**ADDENDUM NO. 1  
TO THE**

**GARDENDALE AND VILLAGE PARK WEST PRESSURE REDUCING STATION (PRS) REPLACEMENT PROJECT**

June 10, 2024

## **ADDENDUM NO. 1 DRAWING REVISIONS**

ORIGINAL SCALE IN INCHES 0 1 2 3 4

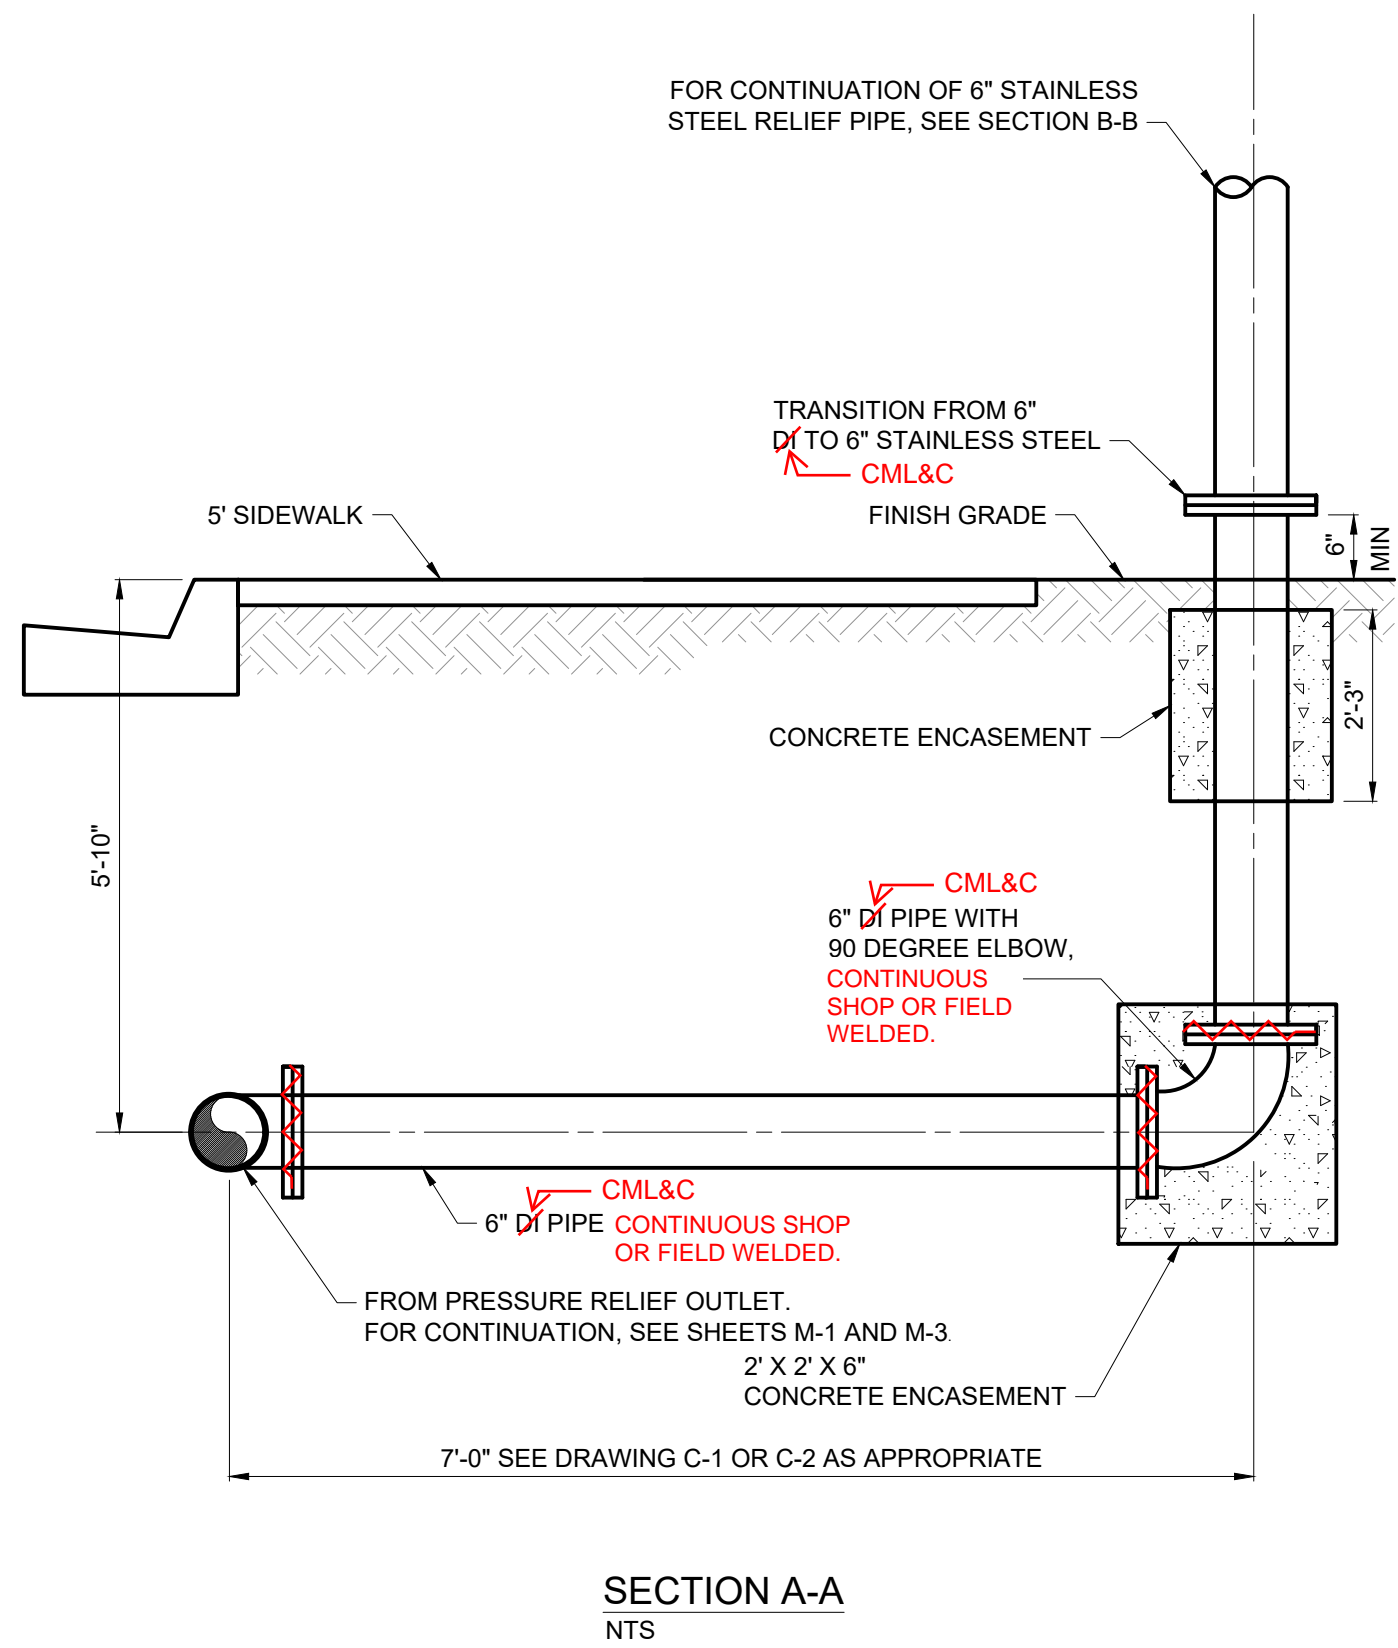
1. Drawing G-2 General Notes; **REVISE** per attached Drawing
2. Drawing C-1 Village Park West PRS, Wandering Road 10" Waterline Improvements; **REVISE** per attached Drawing
3. Drawing C-2 Gardendale Road 14" Waterline Improvements; **REVISE** per attached Drawing
4. Drawing C-3 PRS Piping Profiles I; **REVISE** per attached Drawing
5. Drawing C-4 Curb Outlet Sections; **REVISE** per attached Drawing
6. Drawing C-5 PRS Piping Detail I; **REVISE** per attached Drawing
7. Drawing C-6 PRS Piping Detail II; **REVISE** per attached Drawing

DRAWING  
C-5

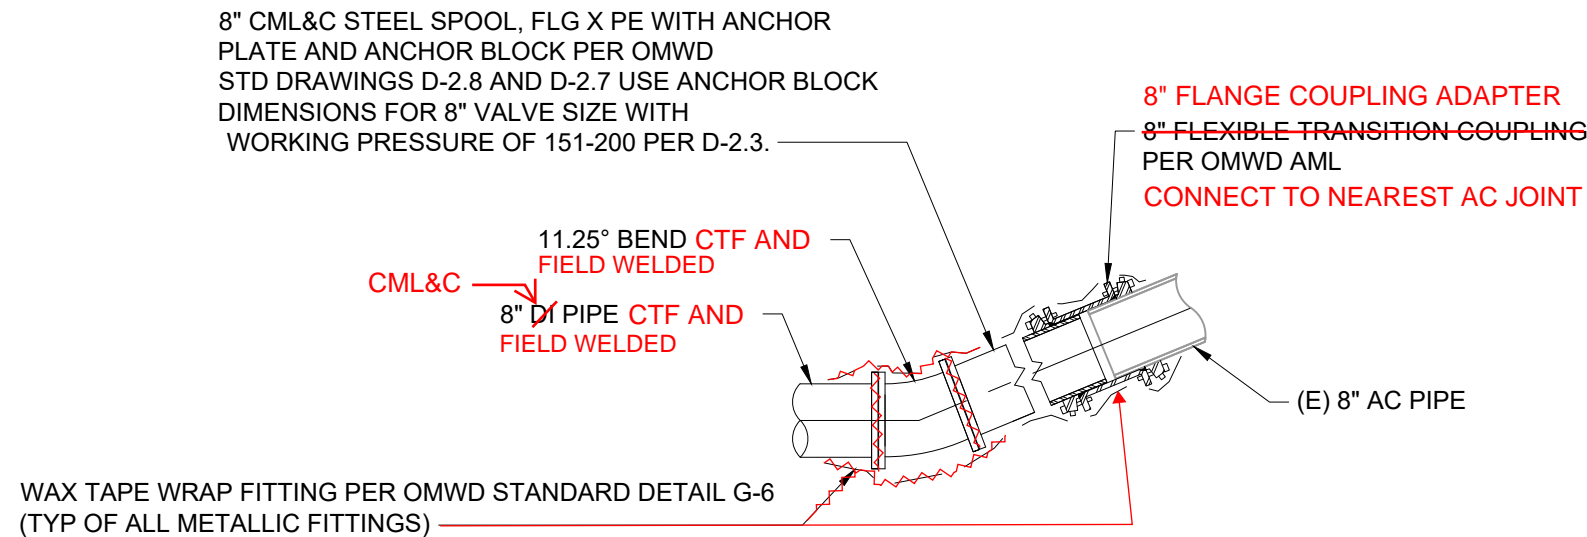
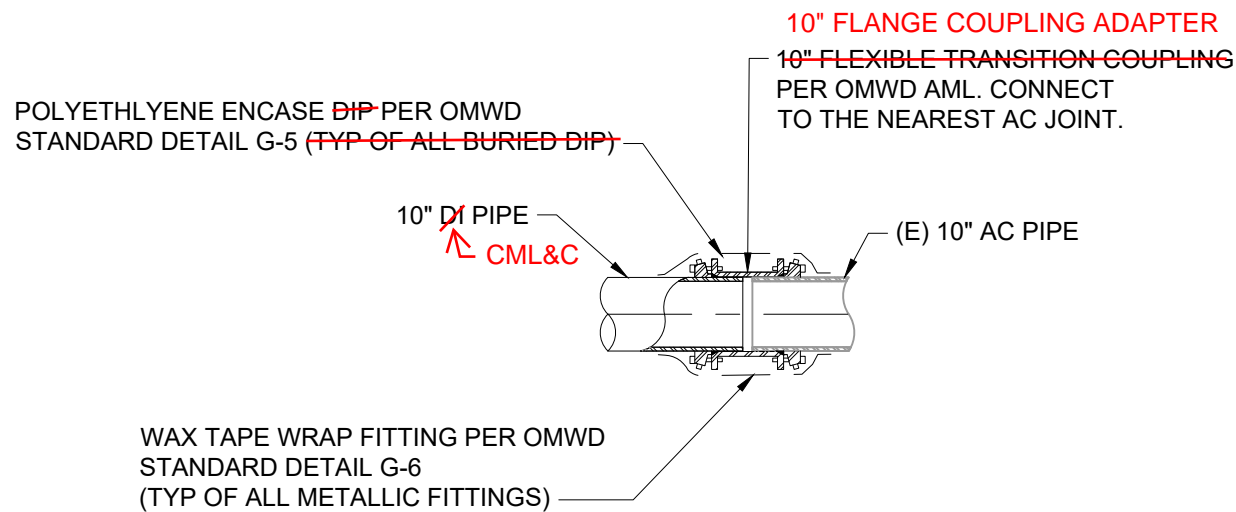
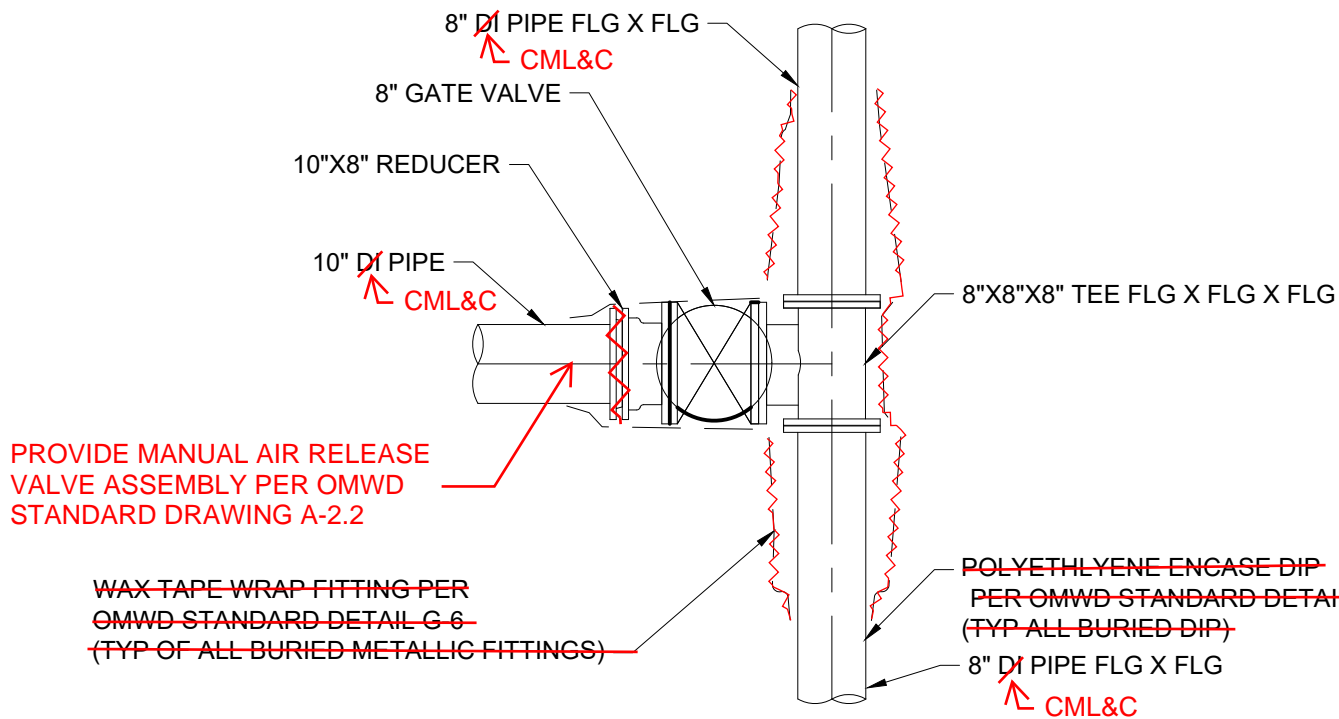
NOTE:  
CML&C STEEL SPOOL JOINTS SHALL BE BONDED PER OMWD STD DWG G-5.
